Application by EPL 001 Limited: Stonestreet Green Solar Project (Application Reference: EN010135)

Responses to Section 51 Advice and Section 55 Checklist

Table 1: Response to Section 51 Advice

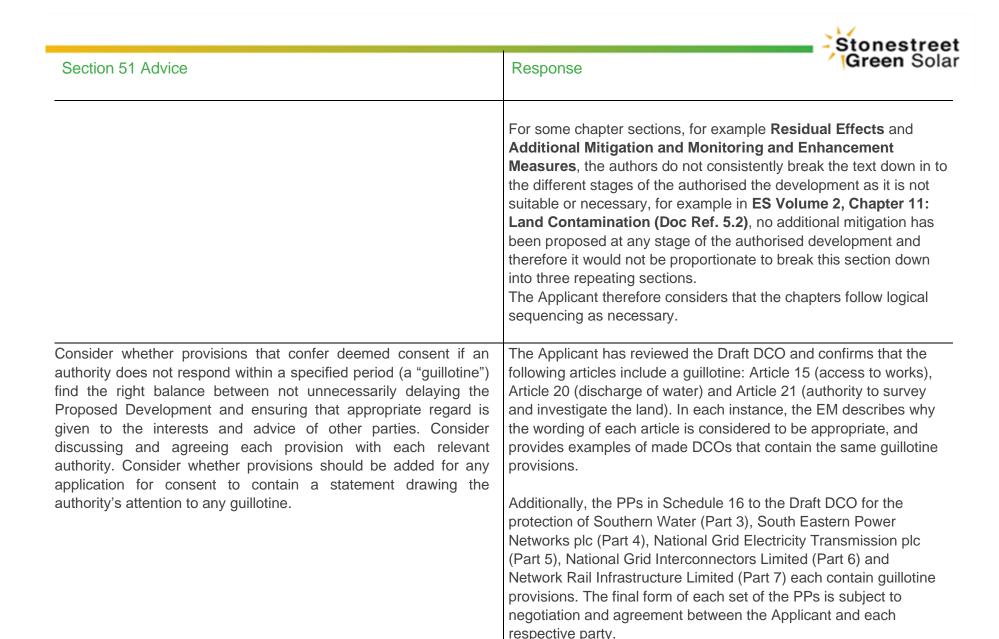
Stonestreet
Section 51 Advice	Response Green Solar
Chapter 12 Socio-Economics (Doc. 5.2) Paragraph 12. 2.1 Wildlife and Countryside Act, the 1 in 1981 is subscript please amend.	Noted. A corrected version of ES Volume 2, Chapter 12: Socio-Economics (Doc Ref. 5.2) has been provided to address this error.
Also consider whether the Climate Change Act 2008 is relevant to the policy and legislation context of the Application submitted.	ES Volume 2, Chapter 12: Socio-Economics (Doc Ref. 5.2) has been updated to refer to The Climate Change Act 2008 ('the Act'). While the Act was not referenced specifically in the Socio-economic assessment, it is referred to in Climate Change Chapter ES Volume 2, Chapter 15: Climate Change (Doc Ref. 5.2) and the Planning Statement (Doc Ref 7.6) and the Applicant considered that this legislation had therefore been referred to where relevant. The Act is the basis for the UK's approach to tackling and responding to climate change, which requires that emissions of carbon dioxide and other greenhouse gases are reduced and that climate change risks are adapted to. The Act required the UK to cut emissions (versus 1990 baselines) by 34% by 2020 and by at least 80% by 2050. The Act was amended in 2019 and there is now a legally binding commitment for the UK to achieve net zero carbon by 2050. The Act therefore informs the approach to policy and decision-making at a national scale, to adopt measures to reduce emissions to that effect by 2050 under the terms of the Act. The commitments within this legislation are reflected primarily in the National Policy Statements and National Planning Policy Framework, which were referred to in the Socio-Economics Chapter and have been used to assess the significance of operational effects relating to the Project's operational phase contribution to national renewable energy generation. Therefore, whilst the updated chapter now refers to the Act, the Applicant considered within the Socio-Economics Chapter assessment.
